Gate Burton Energy Park Environmental Statement

Volume 3, Appendix 10-K: Lincolnshire County Council Consultation Meeting Notes
Document Reference: EN010131/APP/3.3
January 2023

Minutes

Meeting name	Subject	Attendees
Gate Burton Solar Farm	Review of additional viewpoints/photomontages suggested by Lincolnshire County Council	OB - Oliver Brown (on behalf of LCC) JS - Joerg Schulze (AECOM) RW - Rupert Wilson (AECOM)
Meeting date	Time	
30.03.2022	2.30pm	
Location	Prepared by	
MS TEAMS	Rupert Wilson, Joerg Schulze

Viewpoint 4: PRow Carriageway; Upton/N013

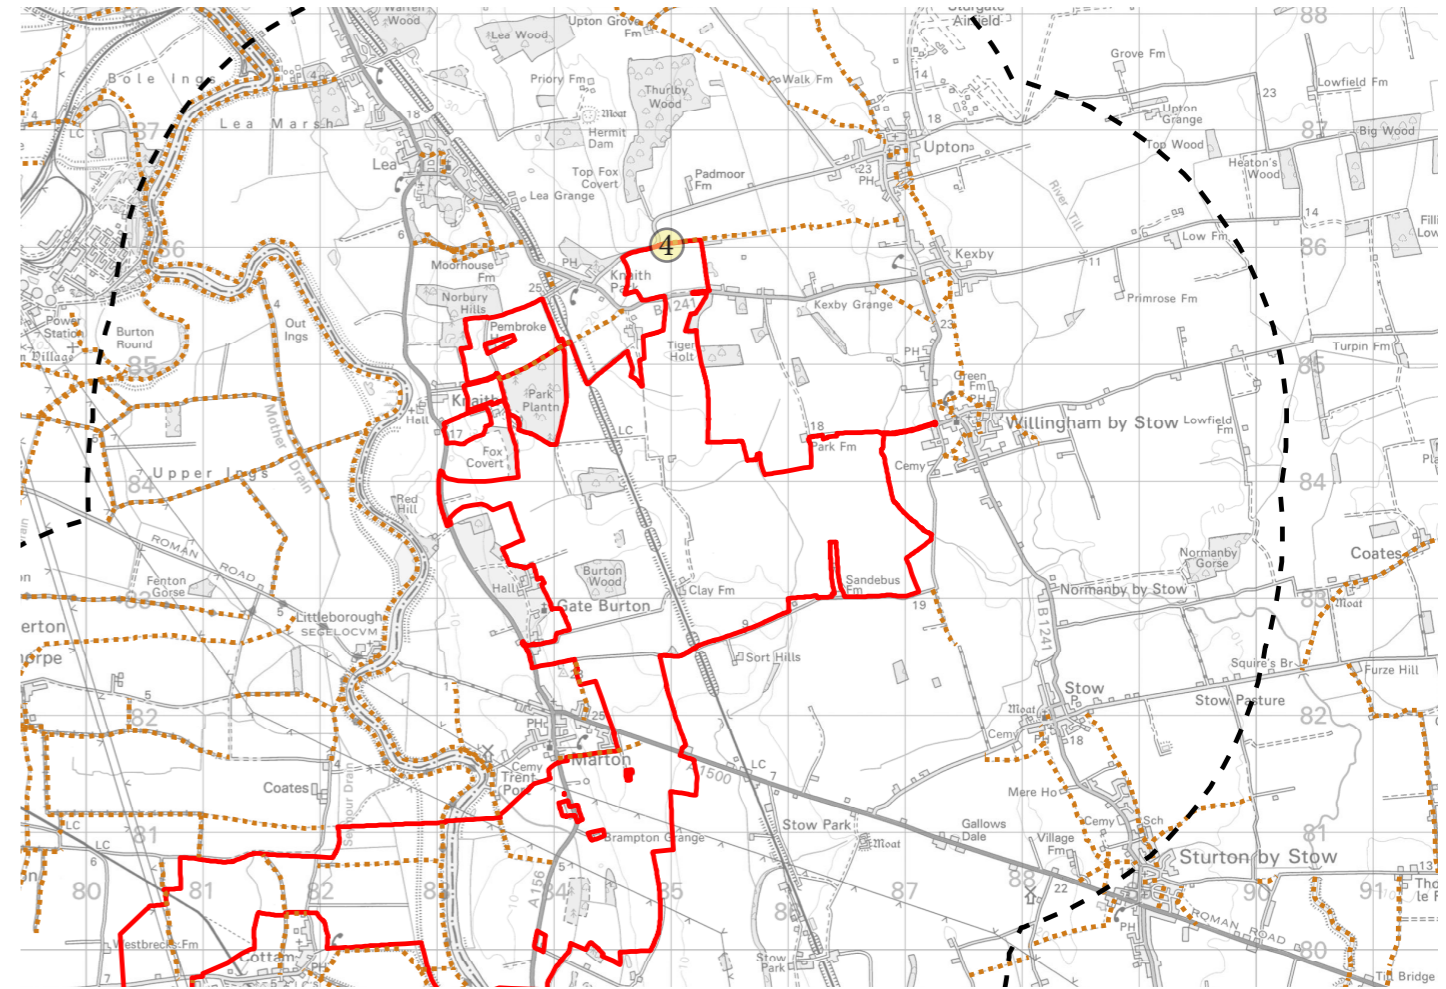
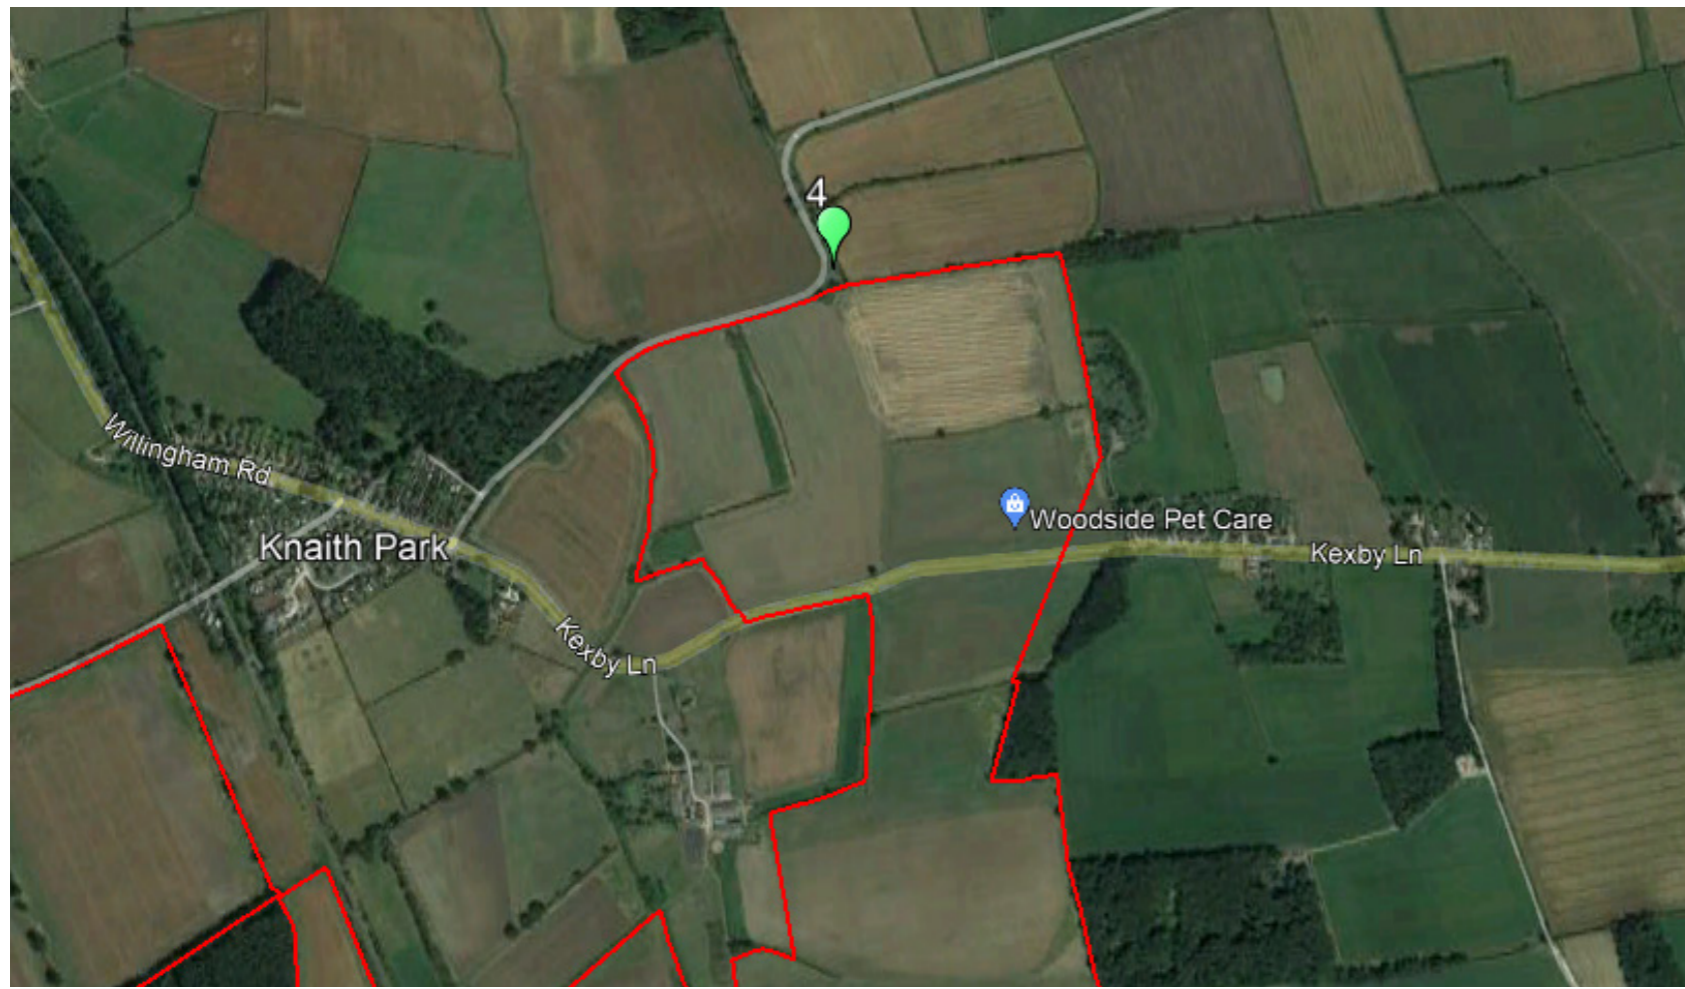
Viewpoint 4 will have a close distance view of the solar panels from this viewpoint.
Photomontage Suggested.

- Viewpoint 4: PRoW Carriageway; Upton/N013 - Viewpoint 4 will have a close distance view of the solar panels from this viewpoint. Photomontage Suggested. **AGREED**

Viewpoint 5: PRow Footpath; Upton/53/1

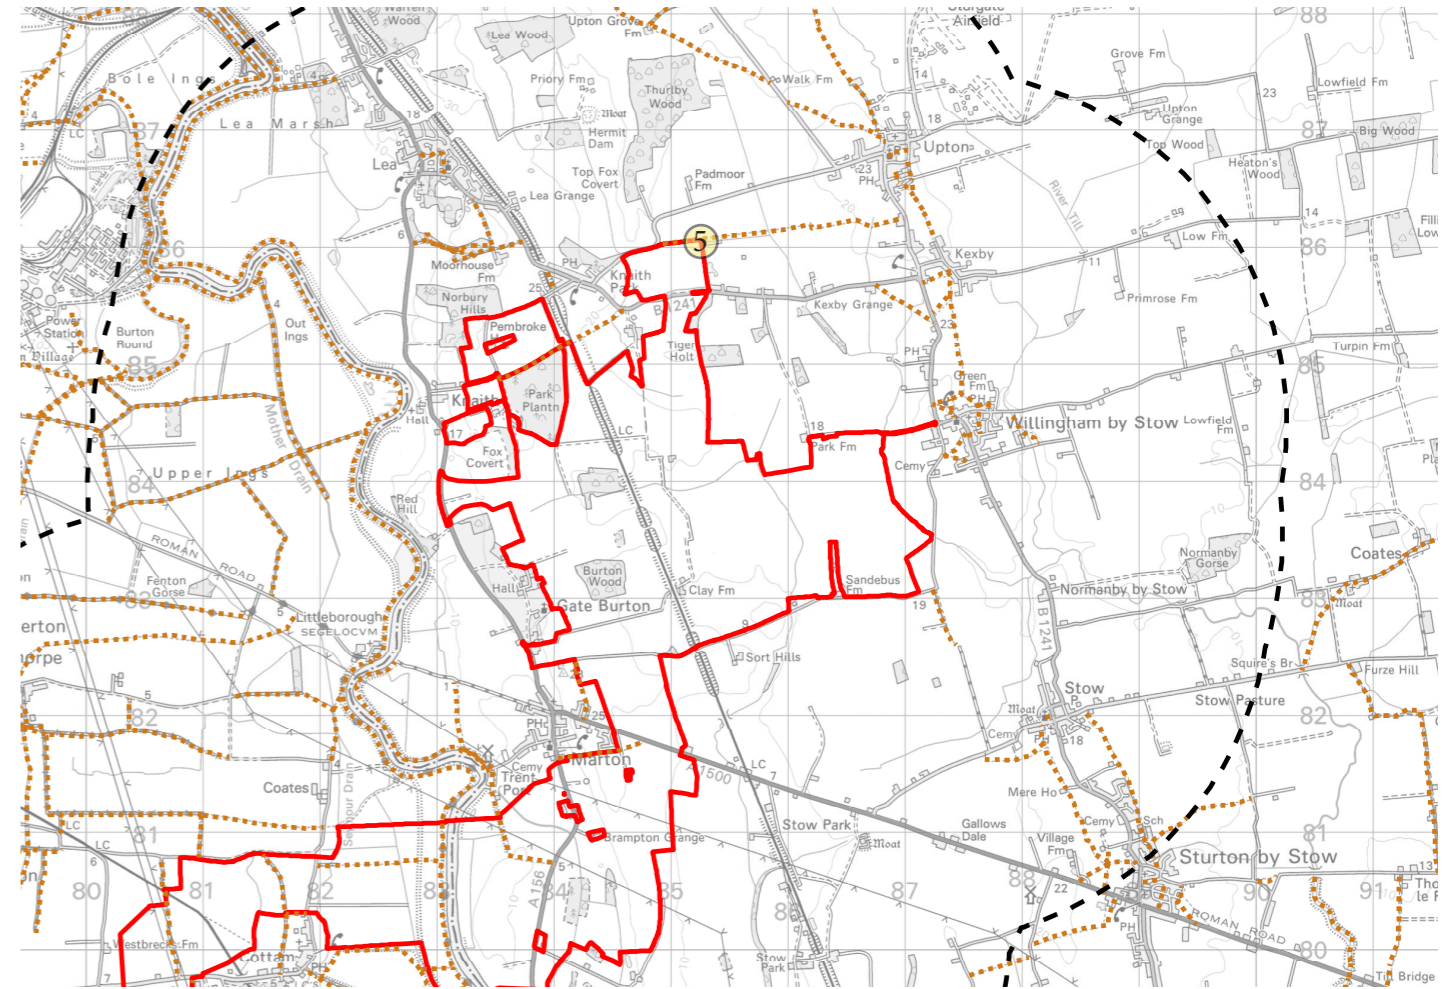
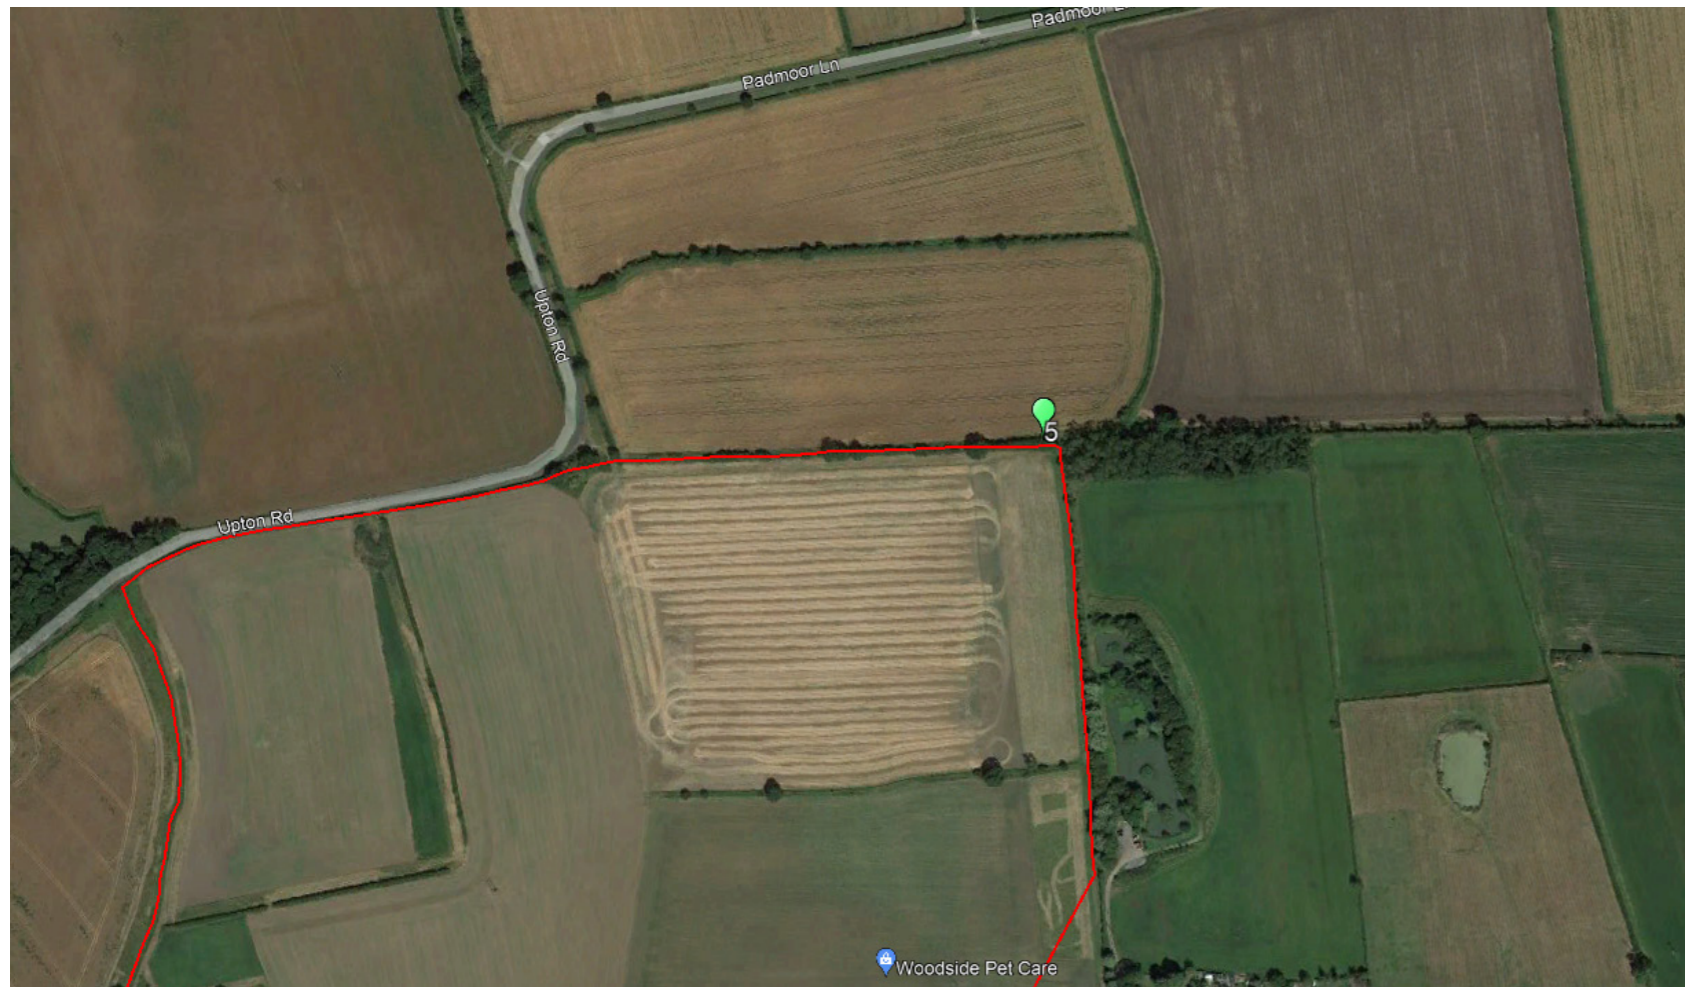
Viewpoint 5 will have a close distance view of the solar panels from this viewpoint, it will however be a brief view due to the screening seen within this image.

Photomontage Suggested.

- Viewpoint 5: PRoW Footpath; Upton/53/1 - Viewpoint 5 will have a close distance view of the solar panels from this viewpoint, it will however be a brief view due to the screening seen within this image. Photomontage Suggested. **AGREED**

Viewpoint 6: Padmoor Lane

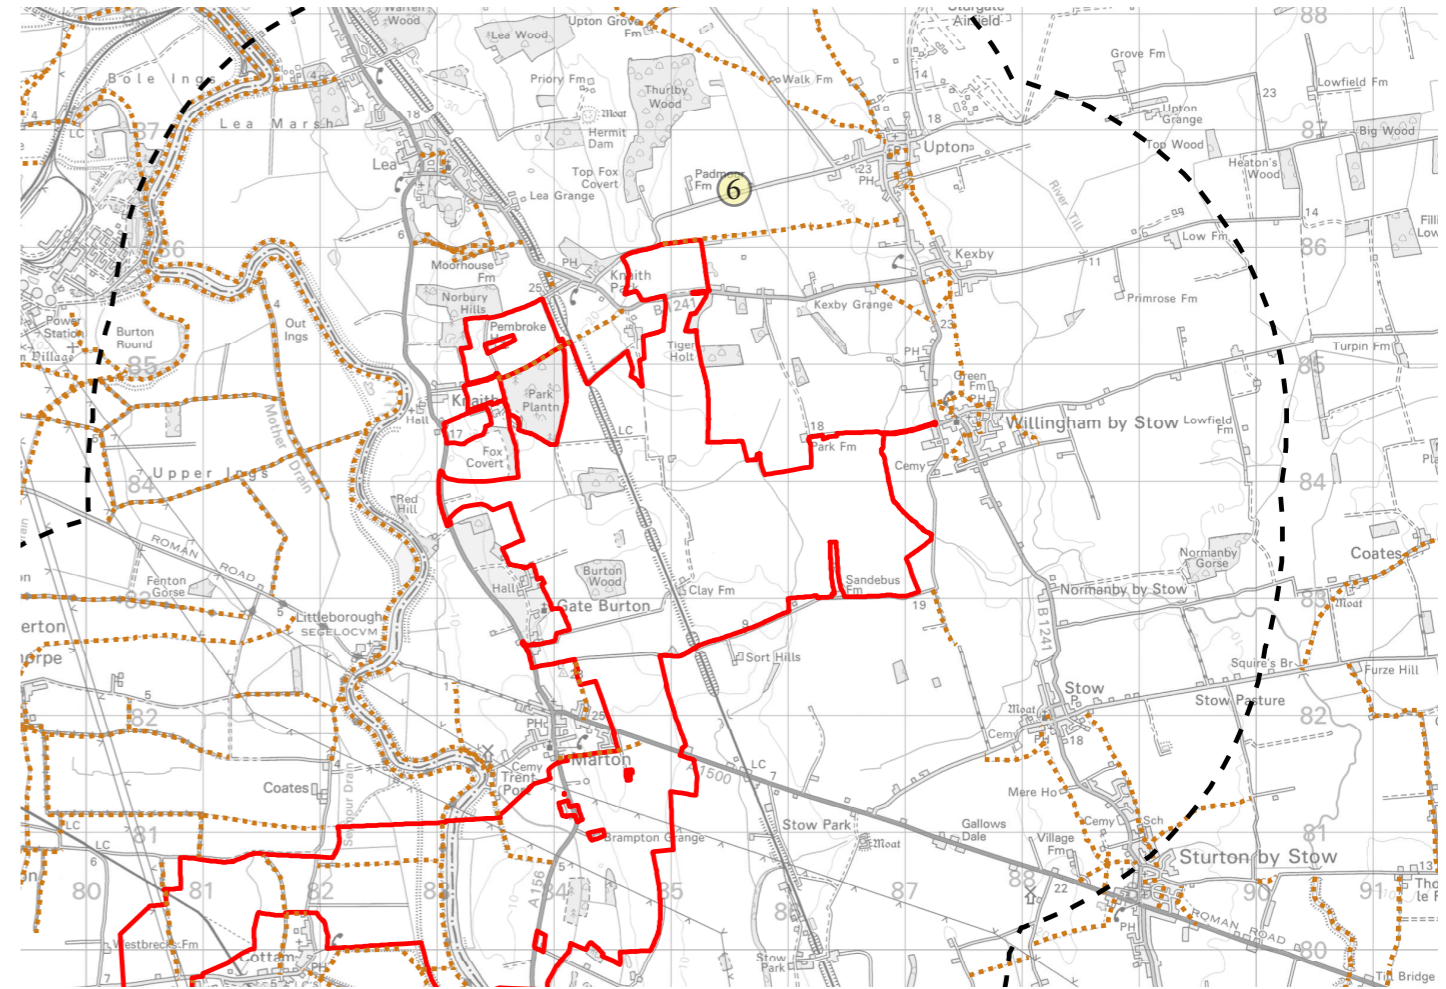
Viewpoint 6 will not have a view of the solar park due to screening provided by the vegetation along the field boundaries seen in this image. **No Photomontage Suggested.**

- Viewpoint 6: Padmoor Lane - Viewpoint 6 will not have a view of the solar park due to screening provided by the vegetation along the field boundaries seen in this image. No Photomontage is Suggested. **AGREED**

Viewpoint 7: Knaith Park PRow - Knai/44/1

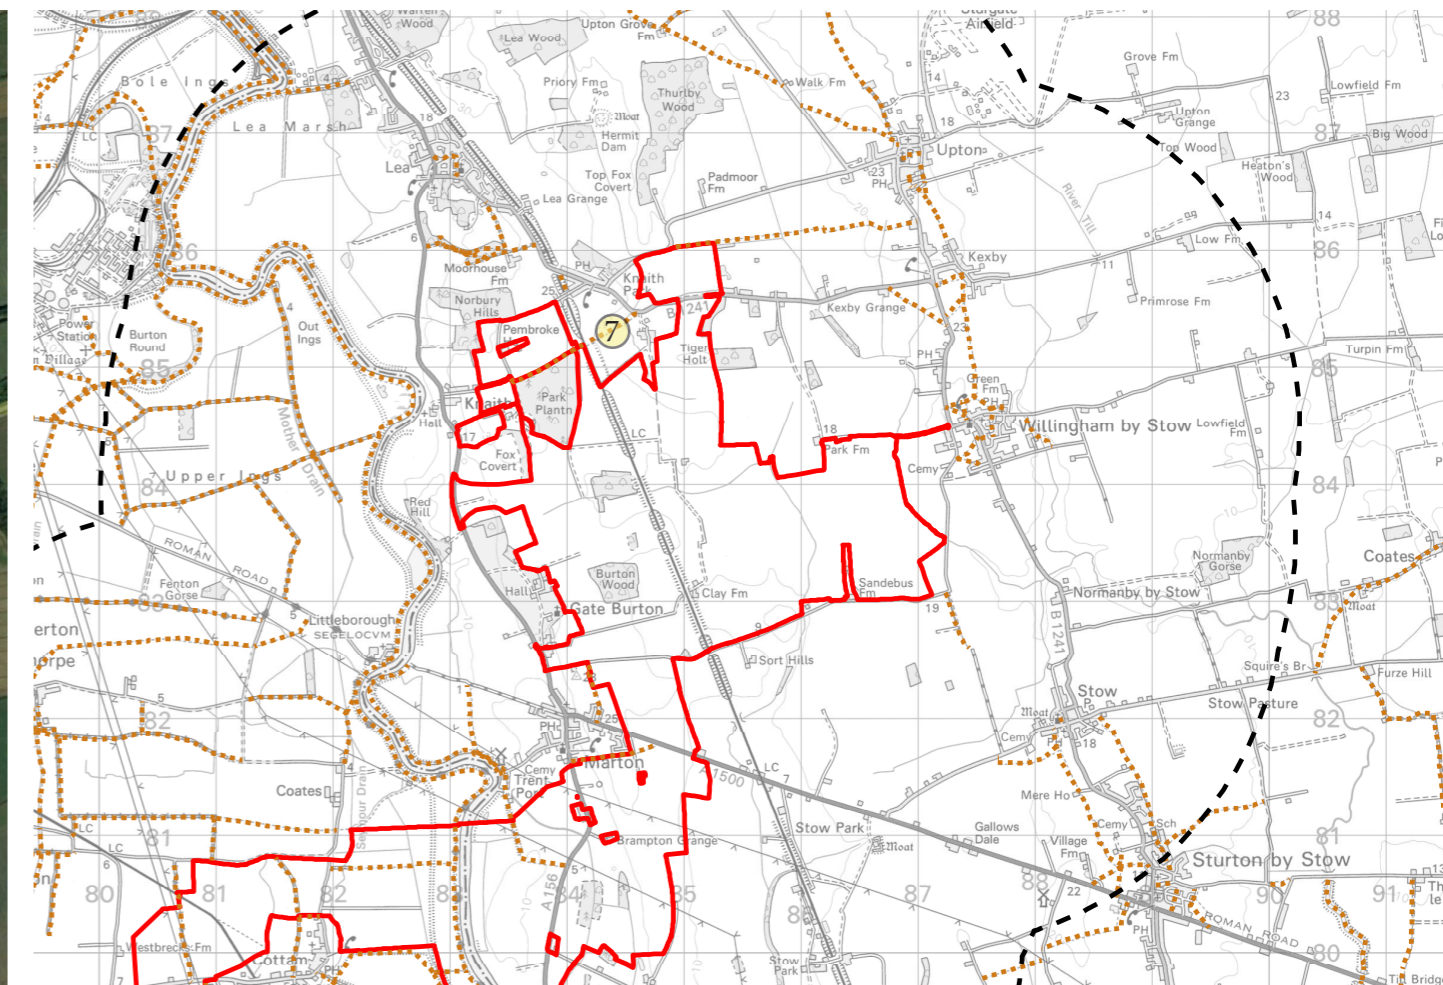
Viewpoint 7 will not have a view of the solar park due to screening provided by the field boundaries seen in this image. **No Photomontage Suggested.**

- Viewpoint 7: Knaith Park PRoW - Knai/44/1 - Viewpoint 7 will not have a view of the solar park due to screening provided by the field boundaries seen in this image. No Photomontage is Suggested. **AGREED**

Viewpoint 8: Station Road

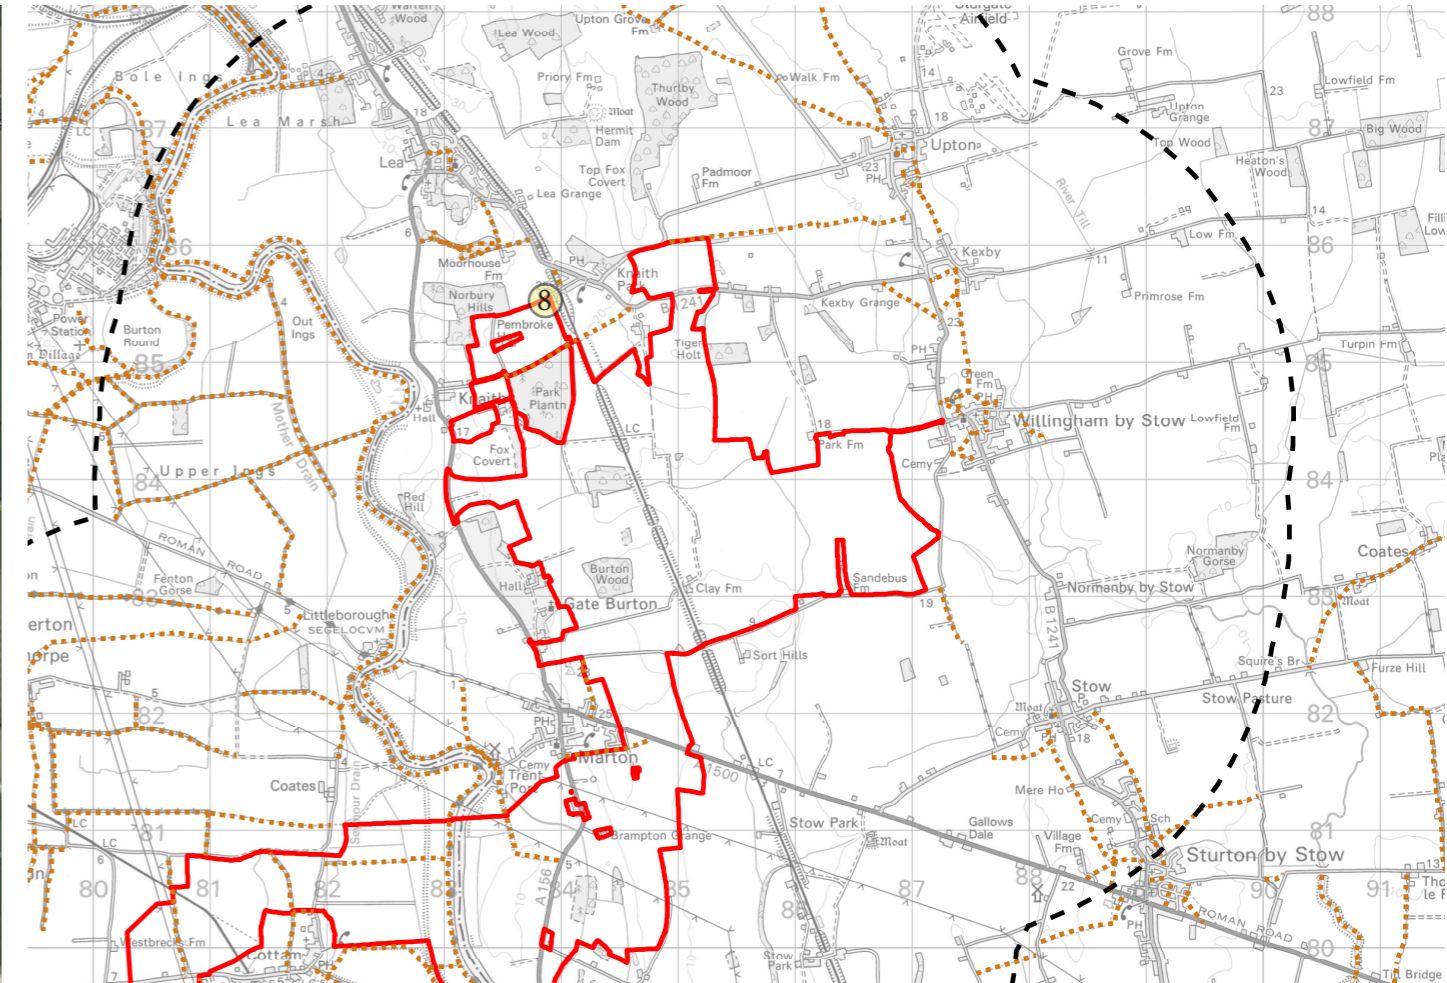
Viewpoint 8 will have a view of the solar park at this viewpoint. **Photomontage Suggested.**

- Viewpoint 8: Station Road - Viewpoint 8 will have a view of the solar park at this viewpoint. Photomontage Suggested. **AGREED**
- Viewpoint 9: B1241 - Viewpoint 9 will have a view of the upper elements of the solar park at this viewpoint. Photomontage Suggested. **AGREED**
